Humid Gas Stress Corrosion Cracking Test for Aluminum alloys

N J Henry Holroyd

16th November 2022

Draft Document for Discussion only
Copyright retained by Dr N J Henry Holroyd

Schematic showing loading conditions

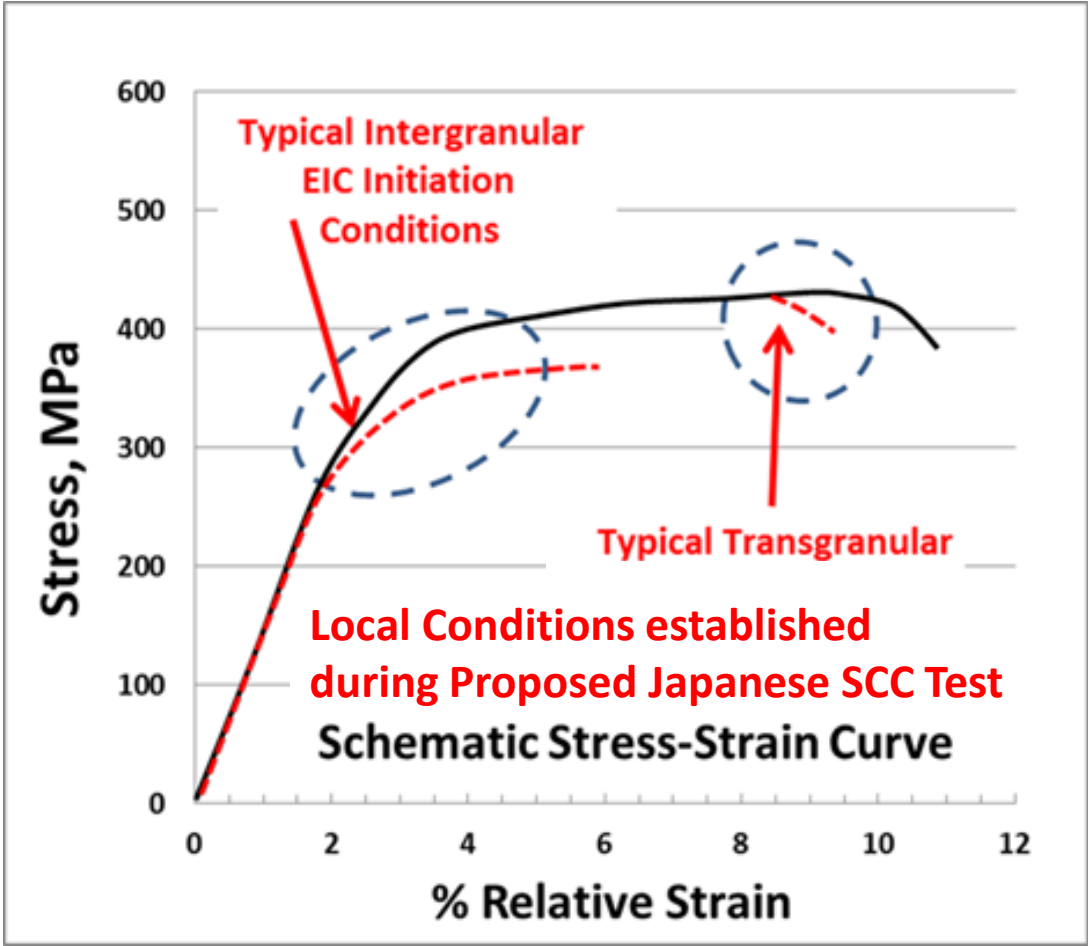
- Japanese research published over last decade or so confirms crack propagation rates for 'long' cracks in AA6061-T6 are enhanced by presence of moisture if mechanical driving forces are sufficiently high (Ogawa et al 2016, 2019)
- Please note: All aluminum alloys show crack growth rate enhancement in humid conditions when subjected to sufficient mechanical loading conditions (see next slide)

- Yes
 - Alternate Test to provide quantitative information:
 - Demonstrating alloys tolerance of 'short' cracks (or other local stress raisers) is adequate to prevent stable SCC propagation under 'worst-case' service conditions, and
 - For use in structural design and service-life prediction
 - Dr Holroyd proposes to customize SCC test development for high-pressure Aluminum all-metal and composite pressure containers.
 - Secondary testing, providing confidence in the alternative test, to be conducted using the OICA proposed test but reducing the initial mechanical loading conditions from $\sim 85\% K_{IC}$ to levels just above the alternate test threshold.
